March 25, 1979  
Howe-101-79

MIDLAND NUCLEAR PLANT - ALAB-106  
MONTHLY REPORT FOR FEBRUARY 1979  
DOCKET NOS 50-329 AND 50-330

LOG OF NONCONFORMANCE REPORTS

1. PROJECT NAME MIDLAND		JOB NO. 7220		19. NO 1879	20. PAGE 1 OF 2		
2. UNIT(S) 1	3. DRAWING/PARTING DRAWING M-619 SH 6	REV 7/P3	4. ITEM DESCRIPTION SPOOL IHBC-100-619-6-4	5. ITEM LOCATION AUX BLDG 584' W. Wing Well

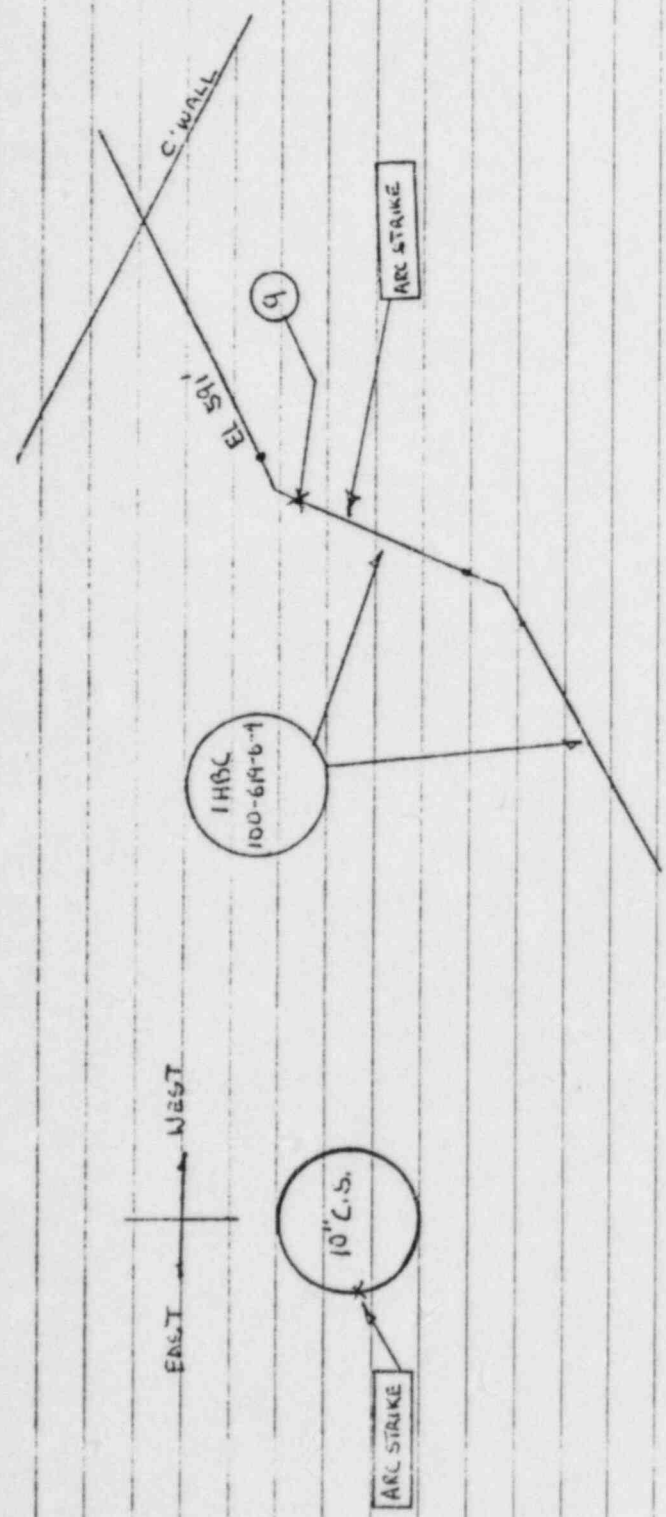
16. NONCONFORMING CONDITION: SPEC M-204 REV. 9-52.1 PARA. 6 STATES: "CARE SHALL BE TAKEN IN HANDLING AND INSTALLATION OF PIPING TO PREVENT SURFACE DAMAGE." SPEC M-204, REV. 9-5.1.3 (M) STATES IN PART: "EXTREME CARE SHOULD BE TAKEN TO AVOID ARC STRIKES UPON ADJACENT SURFACES." CONTRARY TO THAT: SPOOL IHBC-100-619-6-4 HAS AN ARC STRIKE APPROX. 16" FROM F.W. (SEE SKETCH) ARC STRIKE IS APPROX 7/8" LONG, 1/4" WIDE & 29 THOUSANDS DEEP. (LIST # 4.192 - ONE HOLD TAG APPLIED TO PIPE. SEE CONT. SHEET PER CONT. OF BLOCK #16)				24. DISPOSITION CONCURRENCE			
				rework	reject	repair	use as is
				PROJECT FIELD ENGINEER DATE 2/20/79			
				PROJECT ENGINEER DATE			
				PROJ CONSTR QC ENGINEER DATE 2-21-79			
				AUTHORIZED INSPECTOR DATE

1. PROJECT NAME MIDLAND		JOB NO. 7220			19. NO. 1880	20. PAGE 1 OF 2			
2. UNIT(S) 2	3. DRAWING/PART NO. M-604-SH-6	REV 5/F2	4. ITEM DESCRIPTION SPOOL 2HCB-16-604-6-3		5. ITEM LOCATION Aux Bldg. El. 579' Row 215

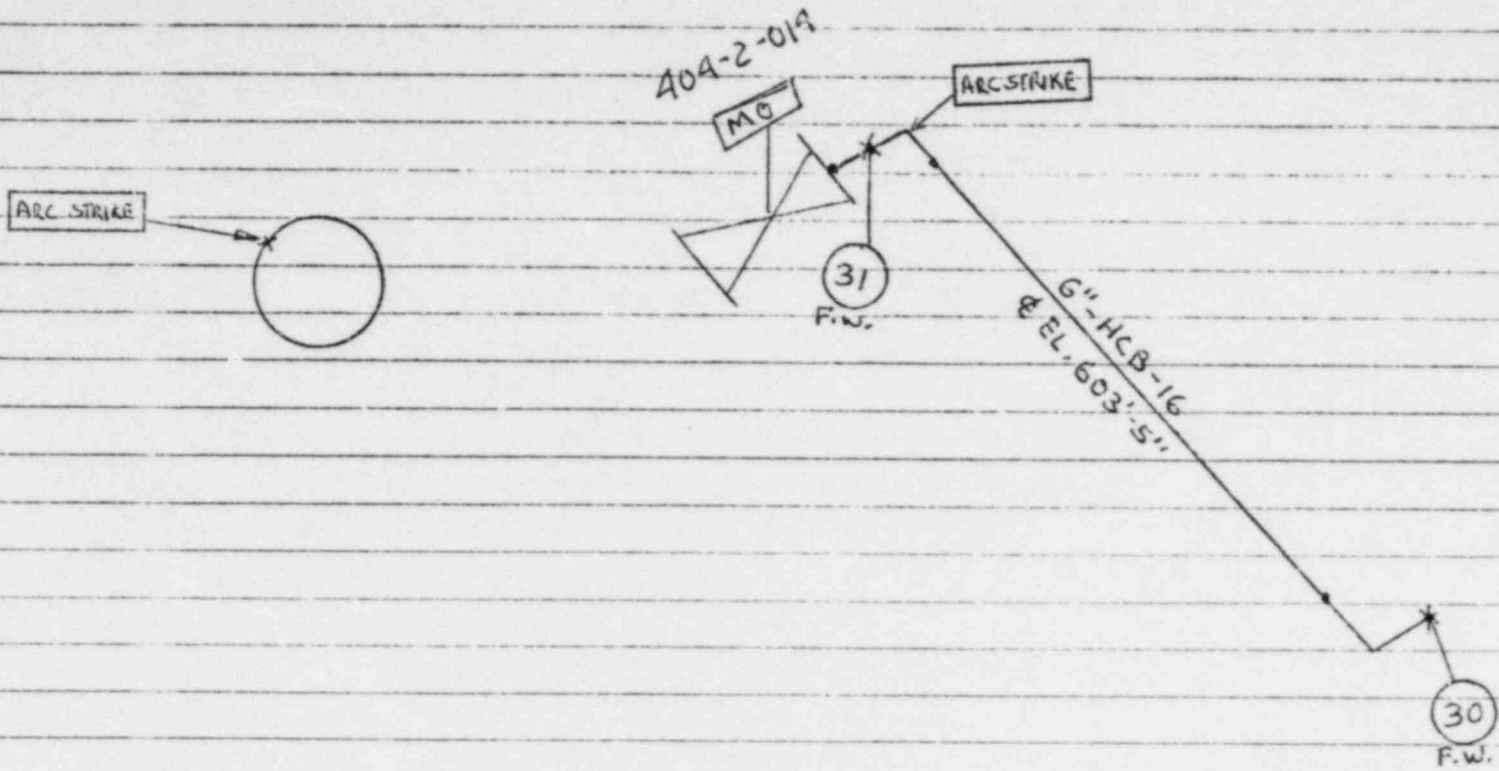
16. NONCONFORMING CONDITION: SPEC M-204 Rev. 9-5.2.1 Para. 6 STATES: "CARE SHALL BE TAKEN IN HANDLING AND INSTALLATION OF PIPING TO PREVENT SURFACE DAMAGE." SPEC. M-204, REV. 9-5.1.3 (M) STATES IN PART: "EXTREME CARE SHOULD BE TAKEN TO AVOID ARC STRIKES UPON ADJACENT SURFACES." CONTRARY TO THAT: SPOOL 2HCB-16-604-6-3 HAS AN ARC STRIKE ON THE NORTH 90° ELBOW, LOCATED AT THE CENTER OF THE INSIDE ARC, 300' ON THE RADIUS. (SEE SKETCH) Q LIST #1097 ONE HOLD TAG APPLIED TO 90° ELBOW. SEE CONT. SHEET FOR CONT. OF BLOCK # 15.						24. DISPOSITION CONCURRENCE			
						rework	reject	repair	use as is
						PROJECT FIELD ENGINEER DATE			
						PROJECT ENGINEER DATE			
						PROJ CONSTR QC ENGINEER DATE			
						AUTHORIZED INSPECTOR DATE

22. <input checked="" type="checkbox"/> Field Engineering Disposition <input type="checkbox"/> Field Engineering Recommended Disposition to Project Engineering									
Field Engineering dispositions-"Repair" per specification 7220-G-270. Procedure specification IRP-1 Rev. 0-inspection and repair of surface defects.

1. PROJECT NAME Midland		JOB NO. 7220			19. NO. 1893	20. PAGE 1 OF 3
2. UNIT(S) # 2	3. DRAWING/PART NO. N/A	REV N/A	4. ITEM DESCRIPTION Corner & Iada Fig. 121-12" & 16" Riser Clamp		5. ITEM LOCATION Station 10

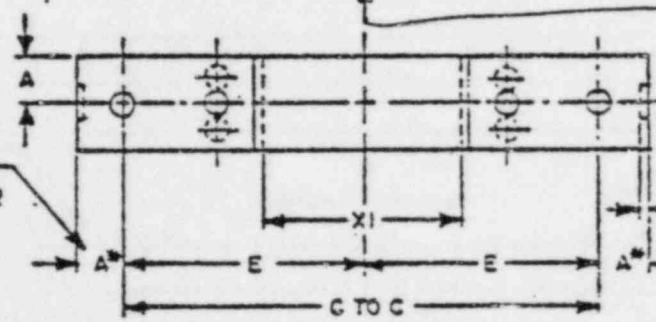
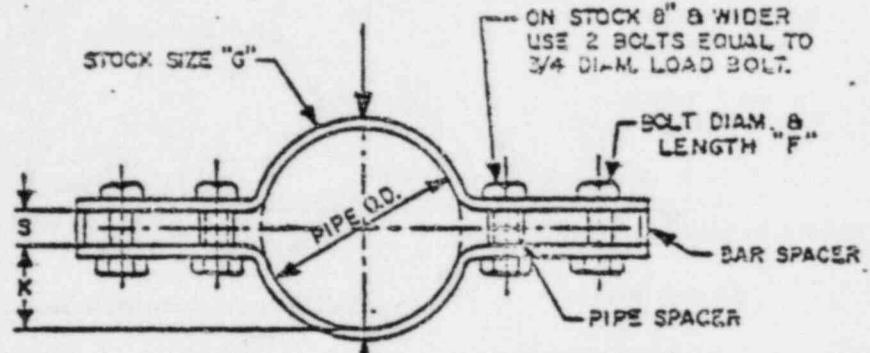
The vendor, in noncompliance with the P.O., supplied longer studs and double nuts.

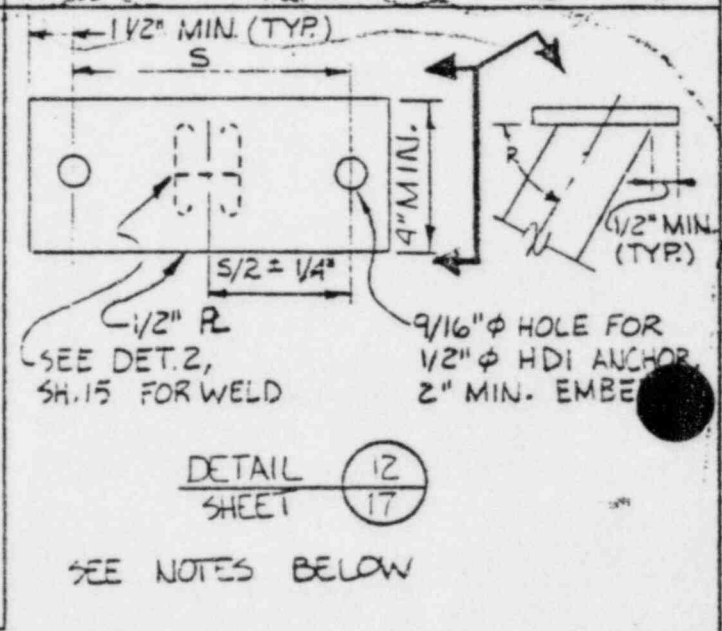
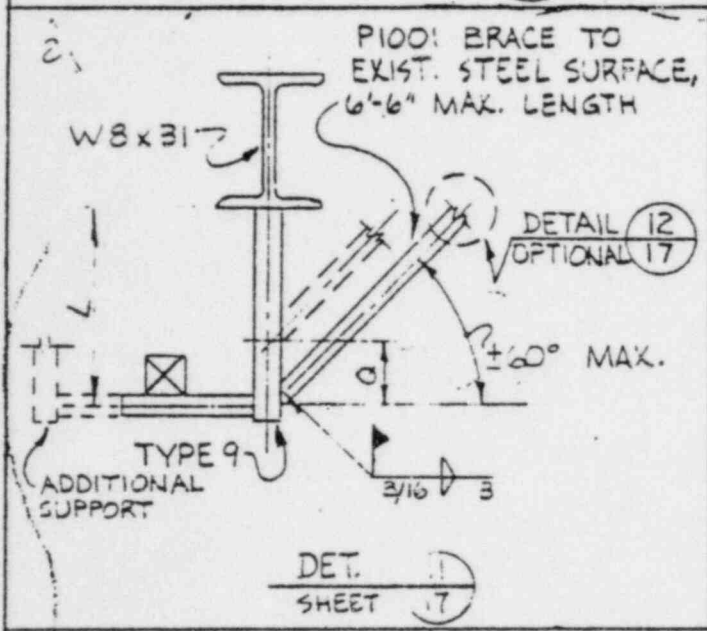
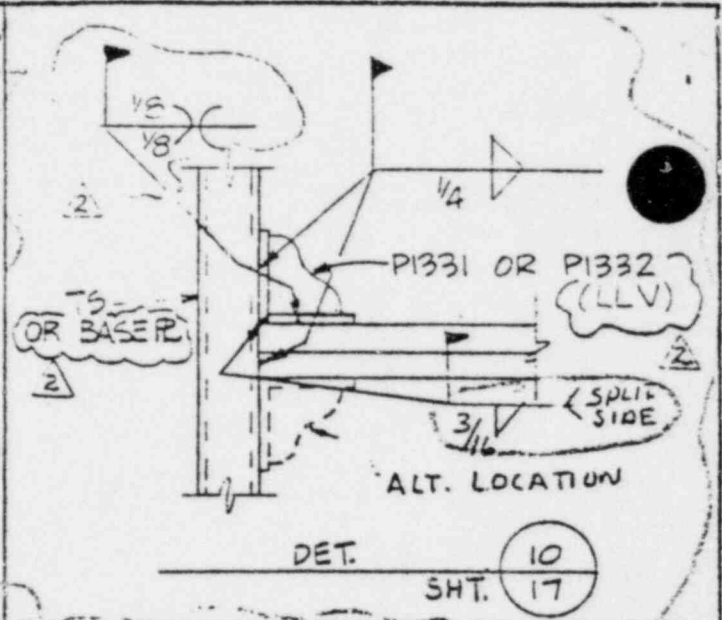
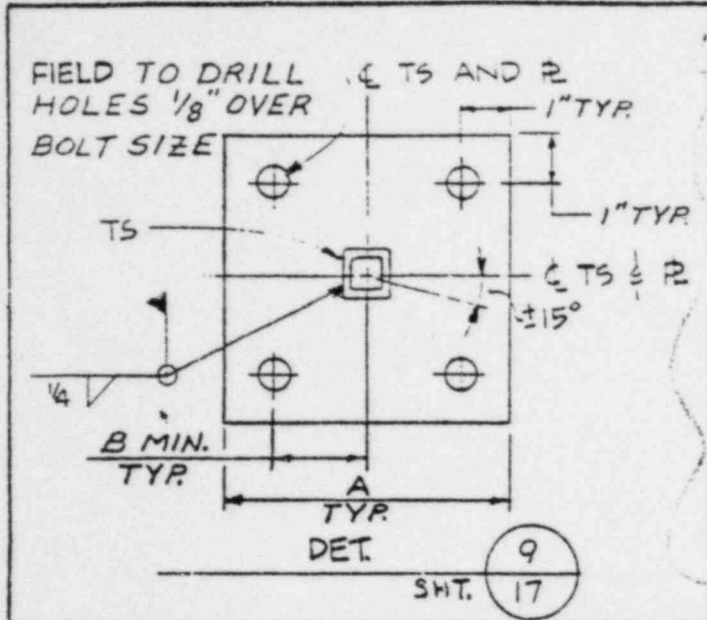
16. NONCONFORMING CONDITION: <i>DWG E39 Q REV 3, SHEET 17, DETAIL 10</i> <i>REQUIRES A 3/16" FILLET WELD ON THE SPLIT SIDE OF PART NUMBER</i> <i>P1331 OR P1332. CONTRARY TO THE ABOVE THIS WELD HAS BEEN</i> <i>OMITTED. HOLD FOR ENGINEERING DISPOSITION. "C" NUMBER 3.006.</i> <i>35 WELD TAGS ADDED</i> <i>13 AH</i> <i>12/19/78</i>				24. DISPOSITION CONCURRENCE		
				rework	reject	repair
						<input checked="" type="checkbox"/> use as is
				PROJECT FIELD ENGINEER DATE <i>J.R. Barnum / REC 1-25-79</i> PROJECT ENGINEER DATE <i>W.L. Barclay / REC 2-1-79</i> PROJ CONSTR QC ENGINEER DATE AUTHORIZED INSPECTOR DATE
